Access Compliance Report

Public Rights-of-Way

Intersection ID: N/A	Main Street: NEW_FASHION_WY	Cross Street: N/A	Location: S
ADA ID: 5098B9B9E478	Ramp Type: Perp	Initial Pass/Fail: Fail	Overall Compliance: No
		Severity Score: 25

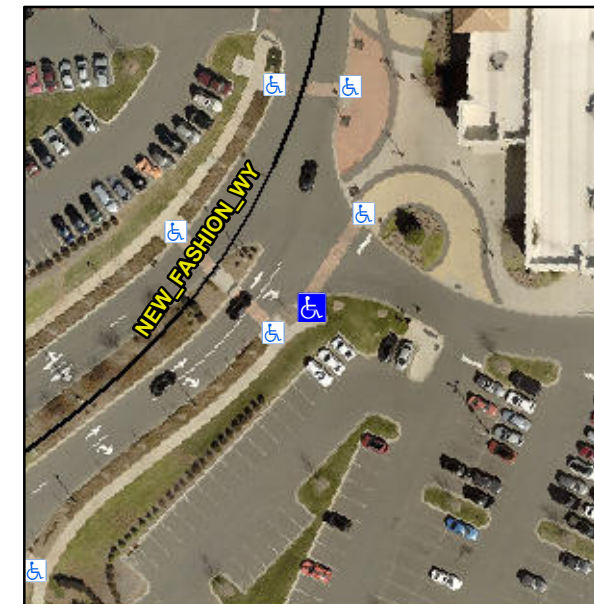
R304.5.3

Compliance	Description	Data	Compliance	Description	Data
N/A	Ramp Length (in)	99.0	Yes	Ramp Slope (%)	7.8
Yes	Ramp Width (in)	48.0	No	Ramp XSlope (%)	9.5
N/A	Flare Type LT	N/A	N/A	Flare Type RT	N/A
N/A	Flare Slope LT (%)	N/A	N/A	Flare Slope RT (%)	N/A
N/A	Flare Traversable LT?	N/A	N/A	Flare Traversable RT?	N/A
N/A	Landing Length (in)	N/A	N/A	DWS Provided?	N/A
N/A	Landing Width (in)	N/A	N/A	DWS Contrast?	N/A
N/A	Landing Slope (%)	N/A	N/A	DWS Length (in)	N/A
N/A	Landing X Slope (%)	N/A	N/A	DWS Full Width?	N/A
N/A	Landing Curb? (Y/N)	N/A	N/A	DWS Offset (in)	N/A
N/A	Shared Landing?	N/A			
N/A	Gutter Ponding?	N/A	N/A	Gutter Slope (%)	N/A
N/A	Gutter Lip Ht (in)	N/A	N/A	Gutter X Slope (%)	N/A
N/A	Painted X Walk1?	Yes	N/A	Painted X Walk2?	N/A
	X Walk 1 Direction	To NE		X Walk 2 Direction	N/A
N/A	X Walk 1 Width (in)	81.0	N/A	X Walk 2 Width (in)	N/A
	X Walk 1 Slope (%)	8.0		X Walk 2 Slope (%)	N/A
	X Walk 1 X Slope (%)	3.8		X Walk 2 X Slope (%)	N/A

Remove & Replace Entire Ramp.
